UNITED STATES PATENT AND TRADEMARK OFFICE

Office Action Summary	Application No. 10/666,542	Applicant(s) APEL, THOMAS R.	
	Examiner Michael B. Shingleton	Art Unit 2815

DETAILED ACTION

Figure 2 (Taniguchi)

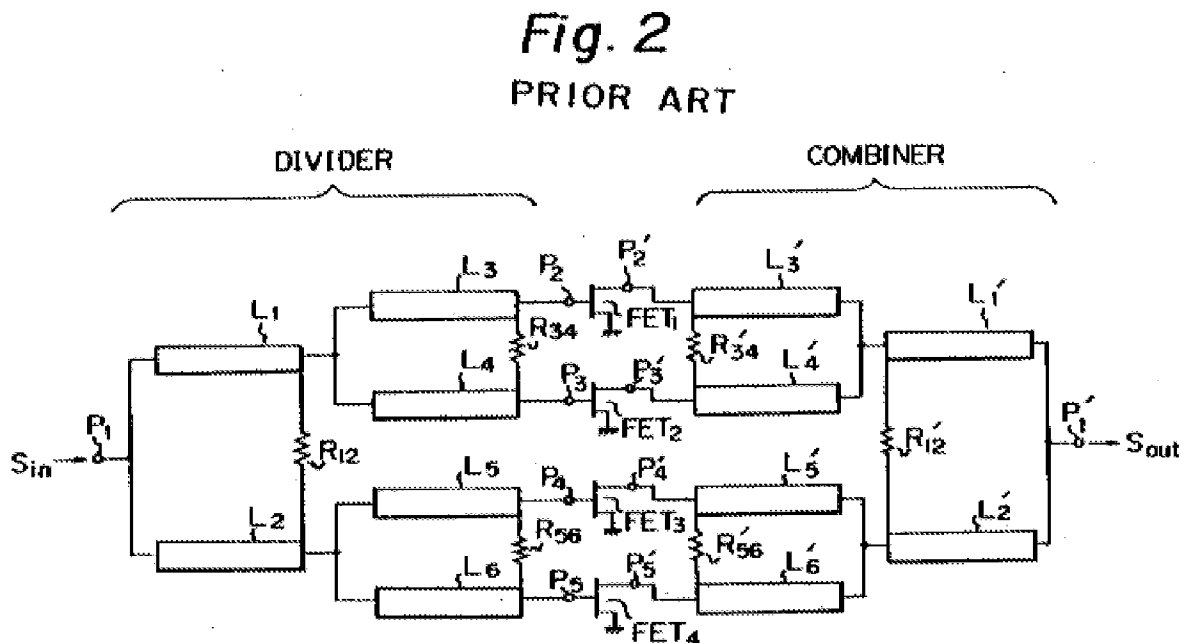
Figure 2 of Taniguchi discloses a power amplifier circuit. Note that the goal of these circuits of Taniguchi is to “obtain a high power high frequency signal” (See column 3, around line 59) and thus these circuits are power amplifier circuits. Taniguchi includes a first amplifier “subsection” L_3 and FET_1 (Herein and throughout referred to just as the first amplifier.) that is configured to receive an input signal that is the unmarked signal at the node that directly connects elements L_1 , L_3 , and L_4 . Note that the first amplifier receives this signal through element L_3 . This is only giving the broadest reasonable interpretation to the claims consistent with the specification. See MPEP 904.01. The first amplifier clearly provides a “first” output signal. Element L_4 of Taniguchi is a first delay element that introduces a delay to the input signal and applies this to the input of a “second” amplifier “subsection” FET_2 (Herein and throughout referred to just as the second amplifier.). This second amplifier clearly has an output signal and provides a “first” delayed output signal to the node directly connecting elements L_3' , L_4' and L_1' . The top of page 9, of applicant’s specification clearly sets forth that an impedance inverter can be a quarter wavelength transmission line. Thus all the quarter wavelength lines of Taniguchi are “impedance inverters” as set forth by applicant and is in accordance with applicant’s application. These impedance inverters of Taniguchi are in accordance with applicant’s specification provides the “impedance inversion”. Thus the impedance/delay element L_3' also introduces a second delay to the first output signal thereby creating a second delayed output signal. The node directly connecting elements L_3' , L_4' and L_1' and the node directly connecting elements L_5' , L_6' and L_2' in combination with the node that directly connects elements L_1' and L_2' provides the means for combining the first and second delayed output signals that ultimately provides the high frequency amplified output signal S_{out} . This output signal is provided on the output terminal “ P_1 ’”. Taniguchi is silent on showing the bias circuit and supply circuit or what applicant calls “level control circuit” in claims like claim 1 for example that biases the first and second amplifiers to operate in the saturation range, i.e. non-linear classes of operation. Applicant should note that while Taniguchi is silent on the bias circuit or “level control circuit”. As is known to those of ordinary skill in the art, Taniguchi inherently must have a bias circuit and power supply circuit because this is a necessary circuit needed so that the amplifier(s) can operate.

The structure indicated above clearly provides for the claimed method of the claims indicated at the beginning of this rejection except for as indicated above Taniguchi is silent on providing a bias control circuit/level control circuit that biases the amplifiers such that non-linear operation is obtained.

Figure 2(Apel)

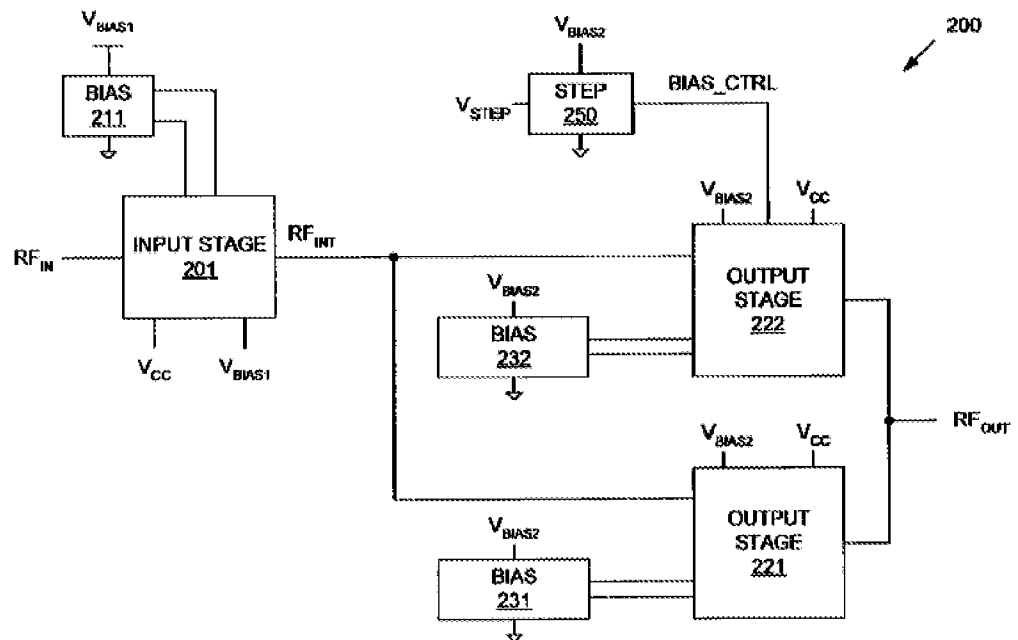
Figure 2 of Apel teaches one way to have a multi-channel amplifier arrangement provide for low power and high power modes. This includes the providing of a “bias control circuit” 231, 232, 250 that enables the first amplifier 221 when the “level control signal” V_{STEP} is set for a low power mode and which enables the second amplifier 222 when the “level control signal” is set for a high power mode.

Thus it would have been obvious to one of ordinary skill in the art at the time the invention was made to provide the combination of Taniguchi and Holt with a bias control circuitry such as that of Apel so as to enable the first amplifier during a low power mode indicated by a level control signal and enable both the first and second amplifiers when the level control signal indicates a high power mode. Therefore the multi-channel amplifier arrangement can be made to provide more than one power level output mode as taught by Apel.

Note that the selection of the bias points of the bias circuits in the combination of Taniguchi, Holt and Apel results in the level control circuit, i.e. the unshown circuit that provides the level control signal V_{STEP} , to allow for the level control circuit to cause the first and second amplifiers to operate in the saturation mode when these amplifiers are enabled.
